## Staff Report

**File #:** 23-286

Appeal of consolidated application for a Subdivision Tentative Plan, Urban Growth Area Preliminary Declaration, Class 3 Site Plan Review, four Class 2 Adjustments, Tree Regulation Variance, and Class 1 Design Review for a proposed six-lot subdivision and multi-family residential development of 436 units (Case No. SUB-UGA-SPR-ADJ-TRV-DR23-02). The subject property is approximately 37 acres in total size, zoned RM-II (Multiple Family Residential), and located at the 2100 Block of Doaks Ferry Rd NW (Polk County Assessor Map and Tax lot 073W17B / 400).

**SUBDIVISION TENTATIVE PLAN / URBAN GROWTH PRELIMINARY  
DECLARATION / CLASS 3 SITE PLAN REVIEW / CLASS 2 ADJUSTMENT /  
TREE VARIANCE / CLASS 1 DESIGN REVIEW CASE NO.: SUB-UGA-SPR-ADJ-  
TRV-DR23-02**

# SDR3

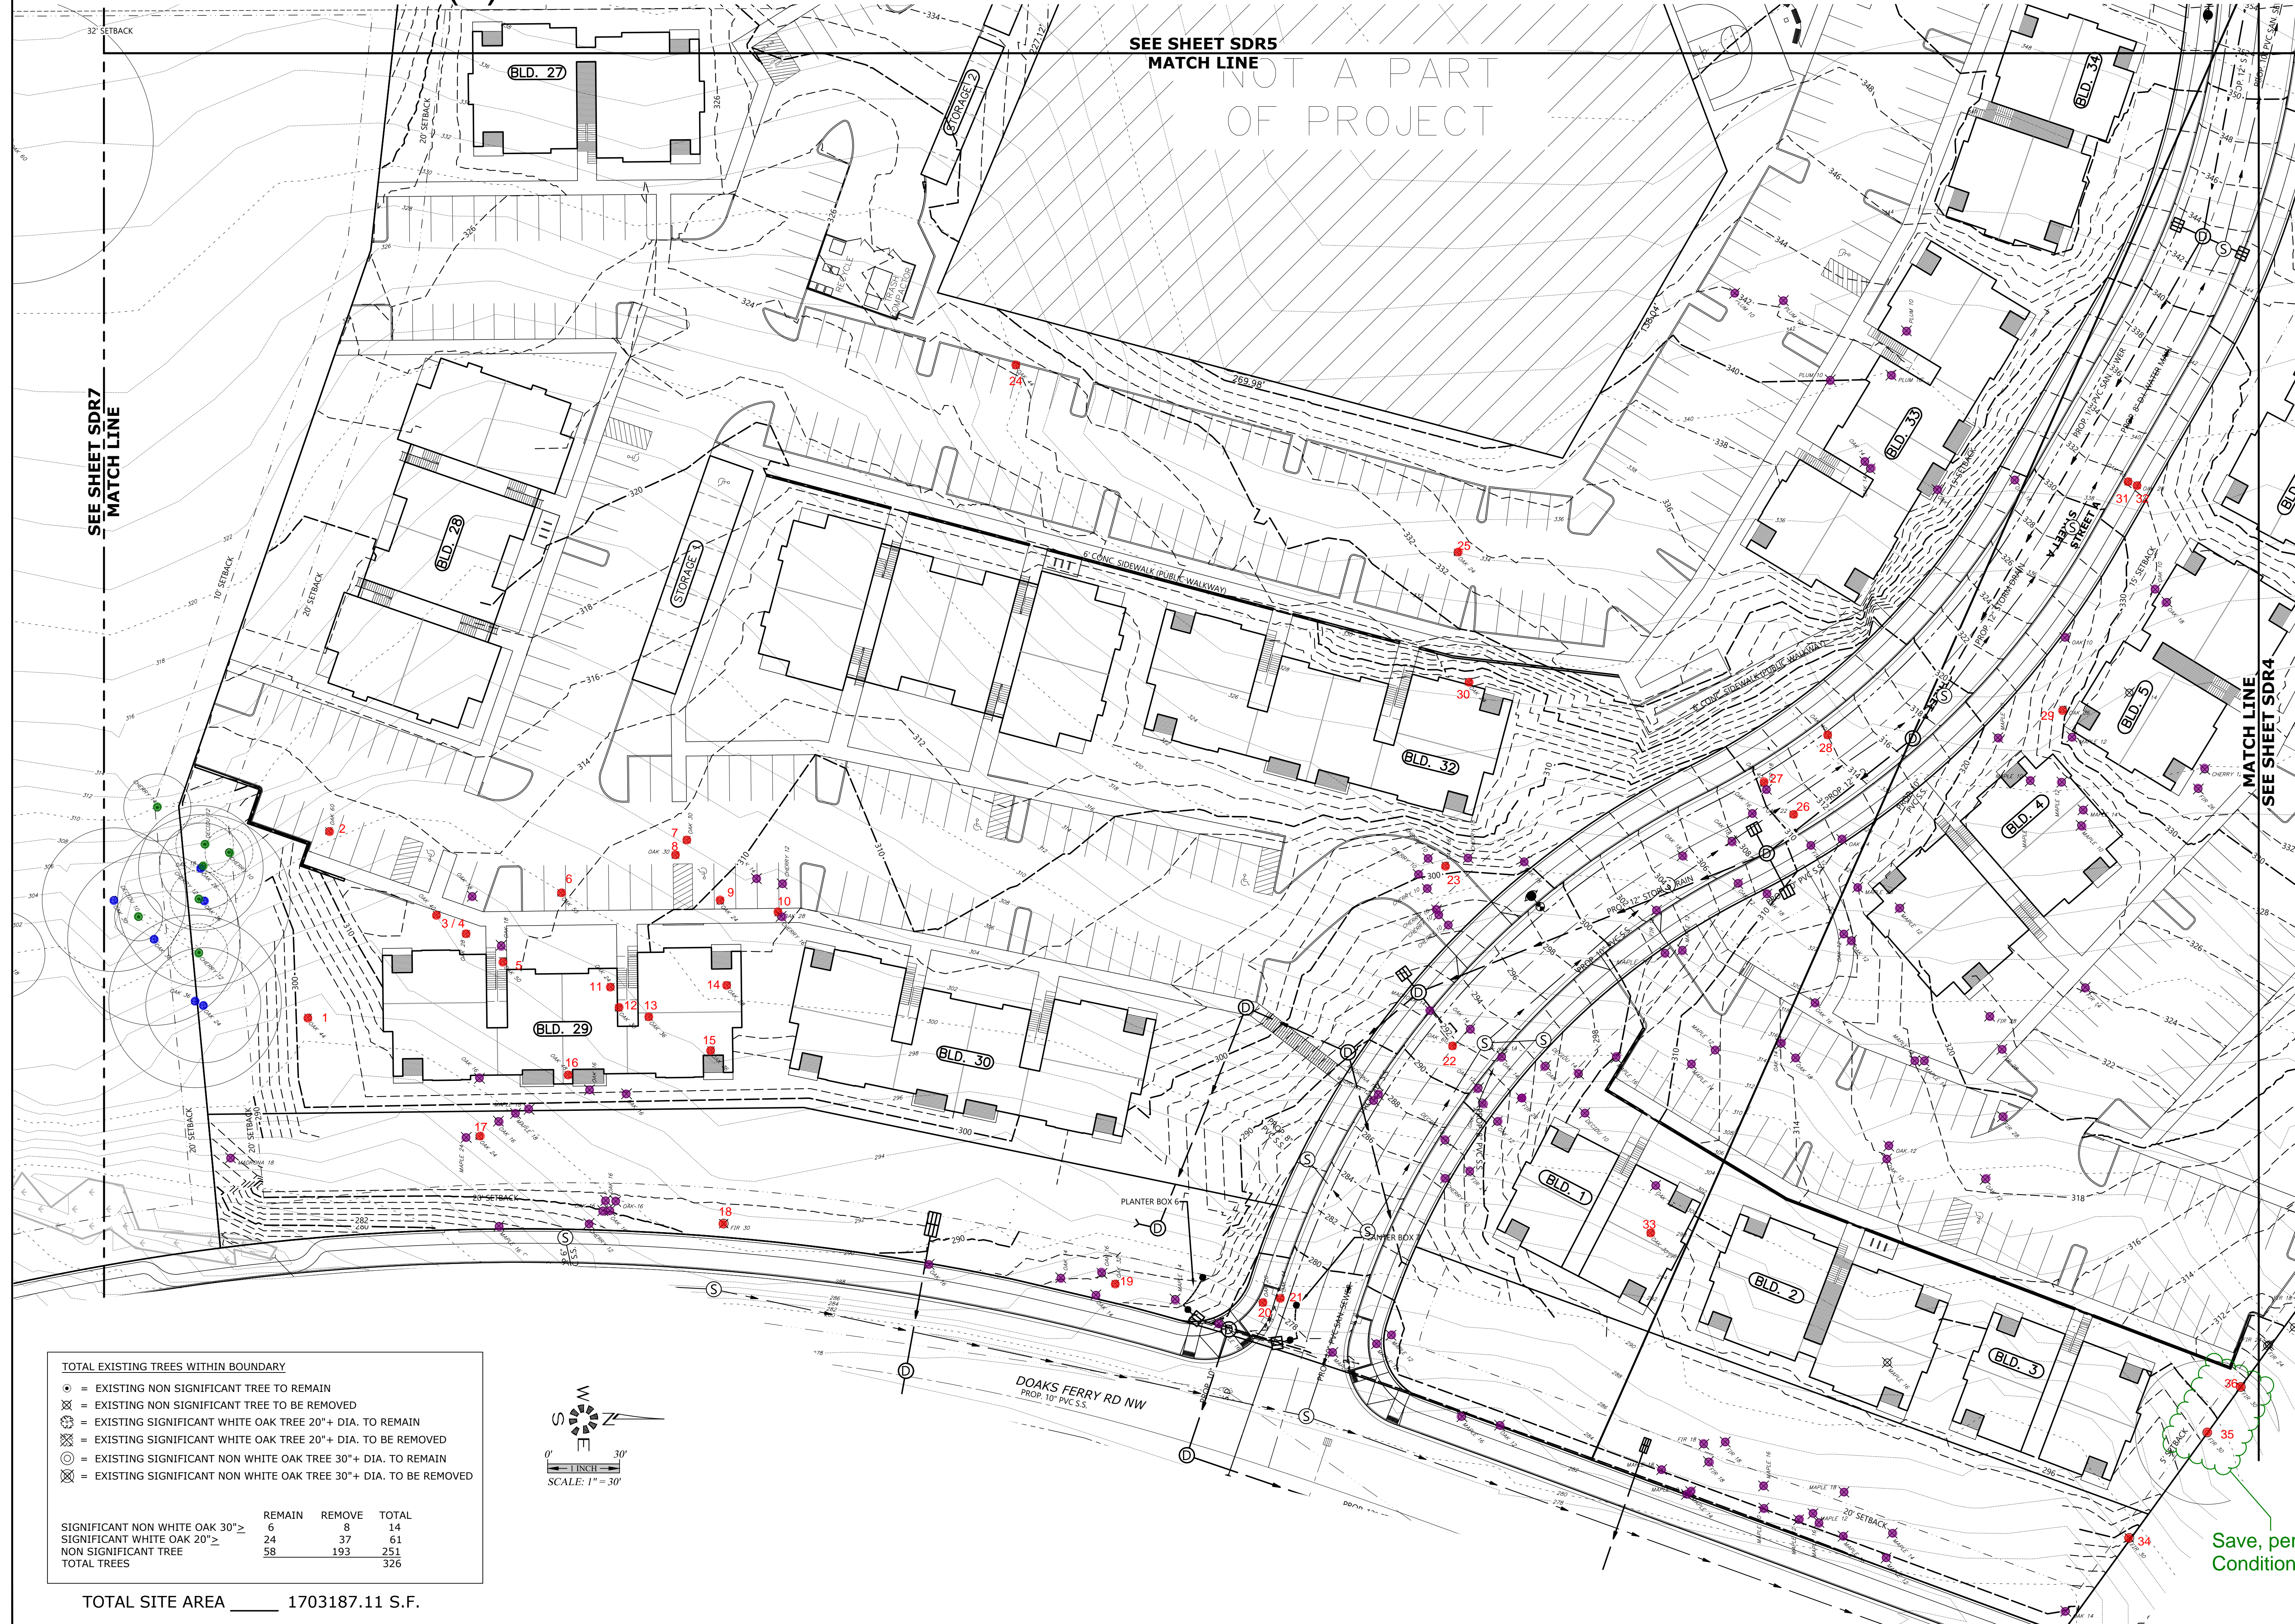
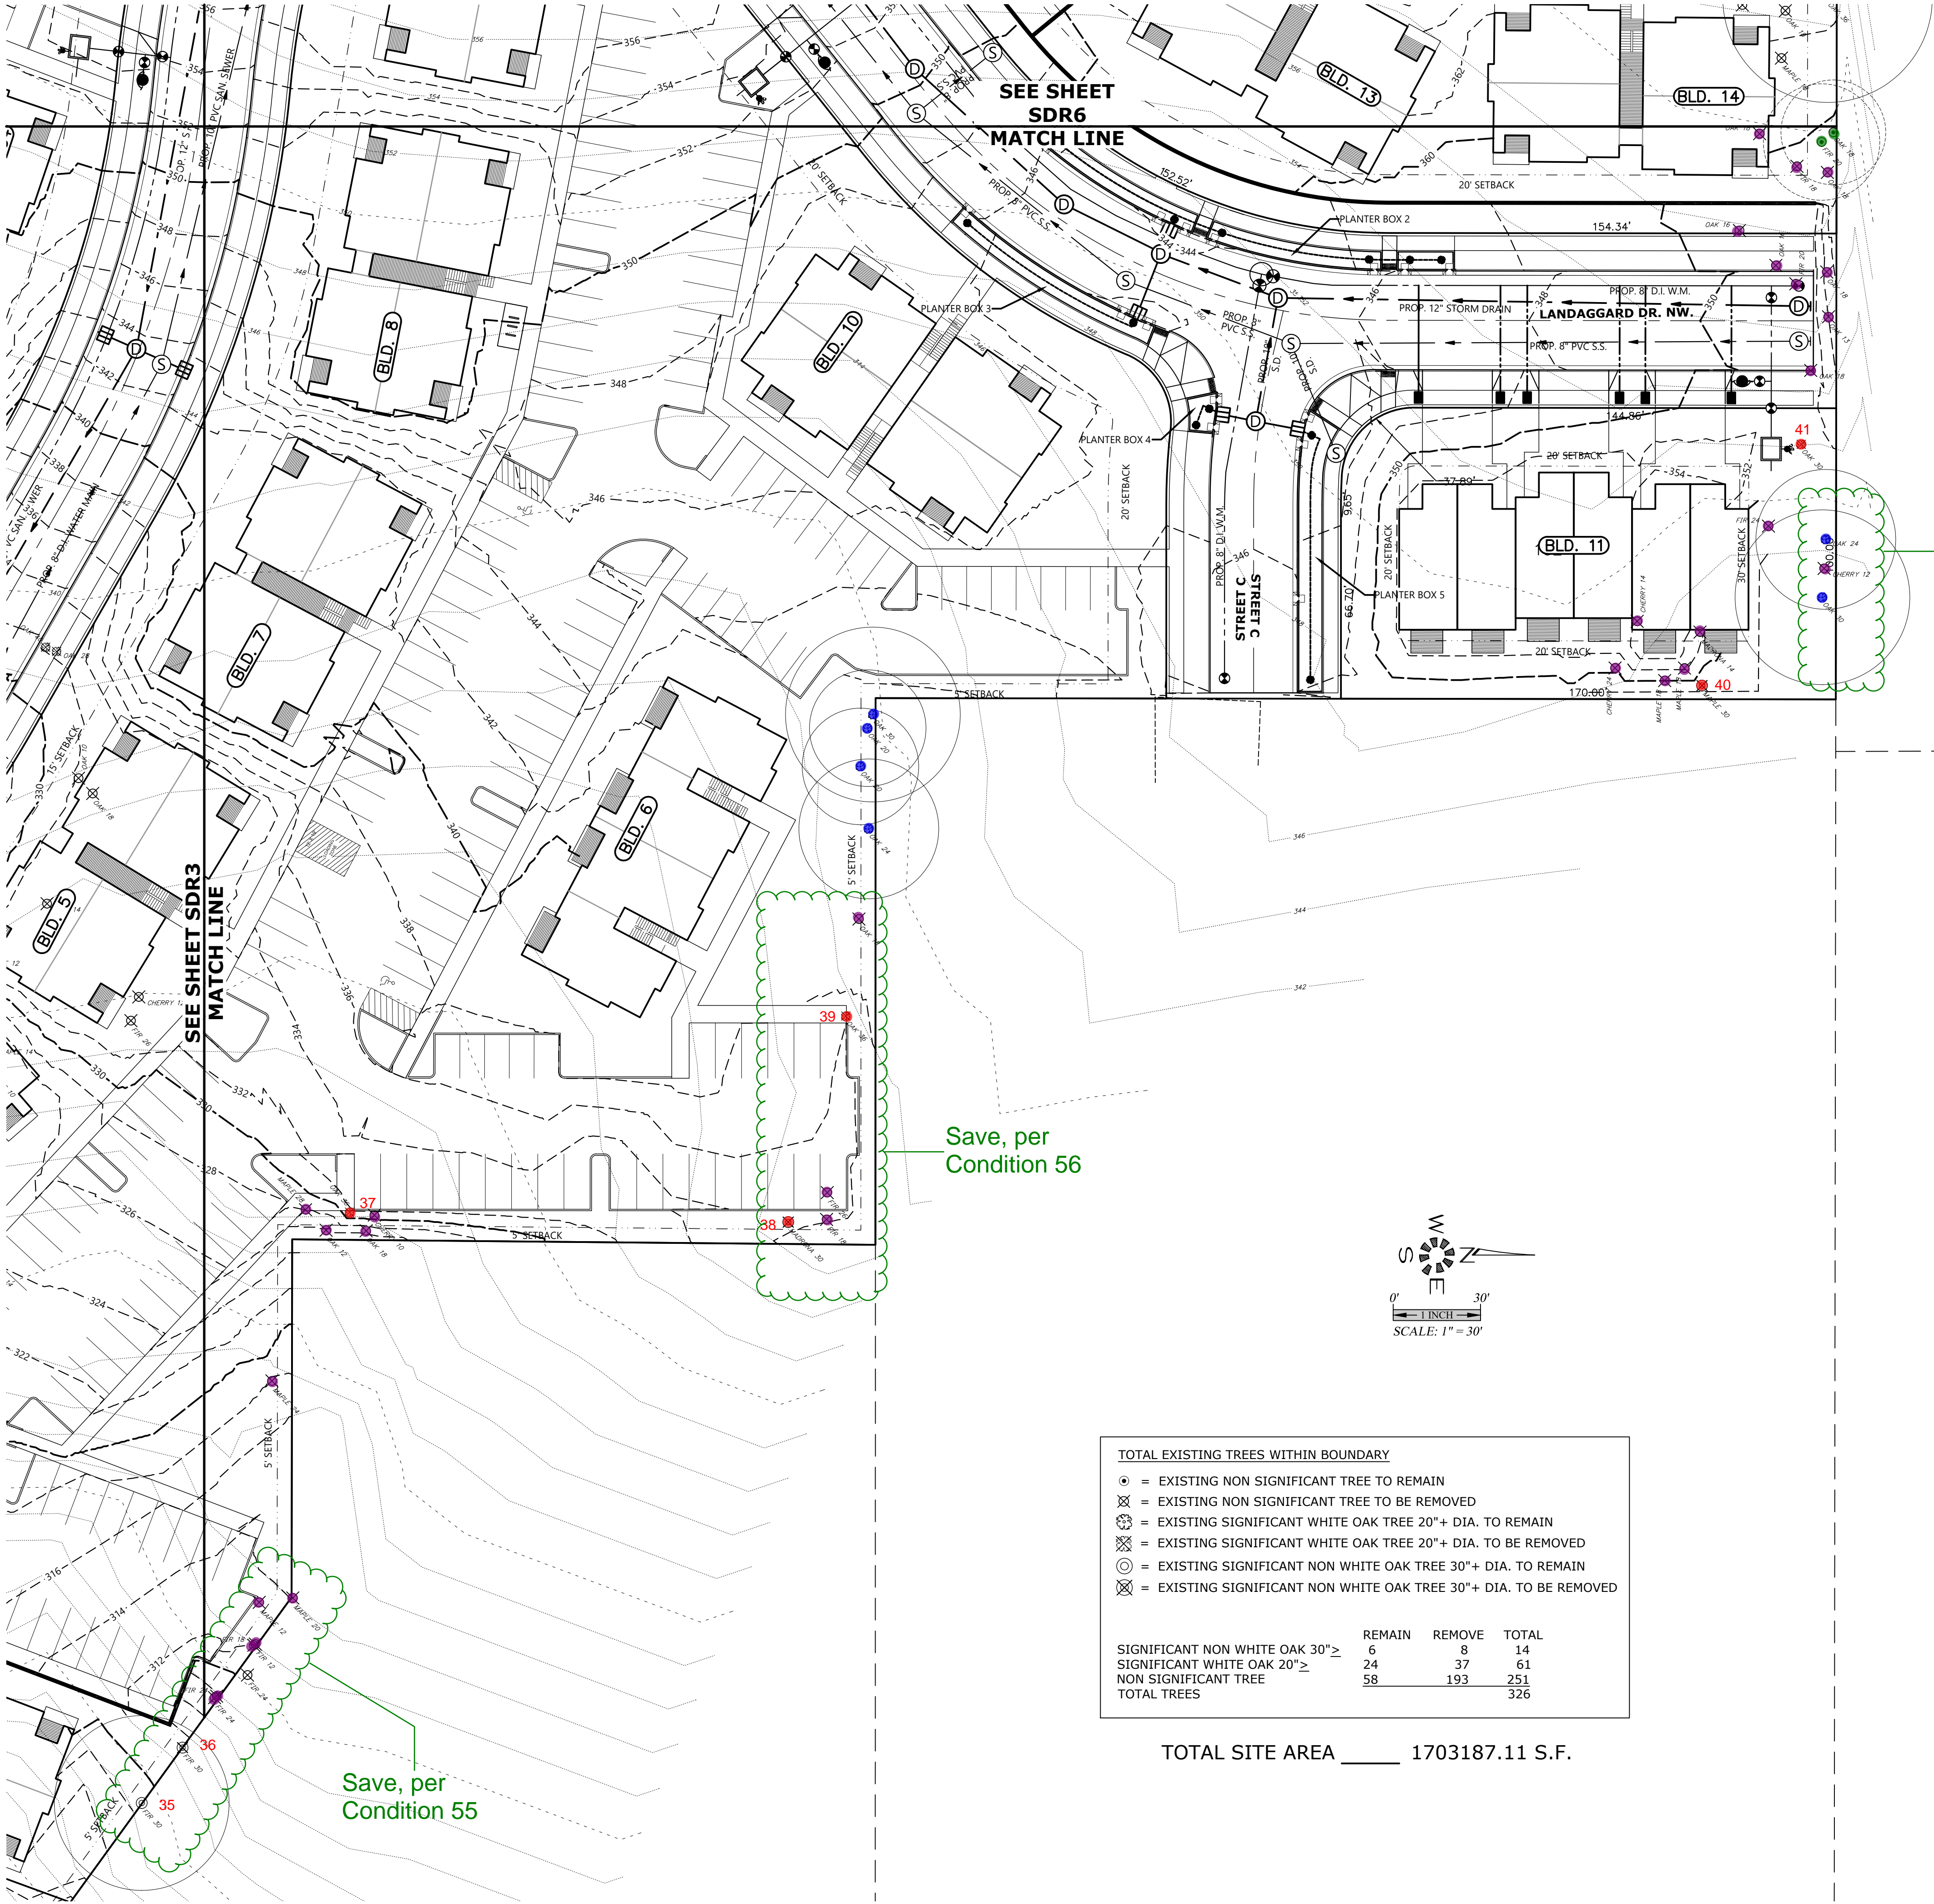
Save, per  
Condition 55

OK to remove for street realignment
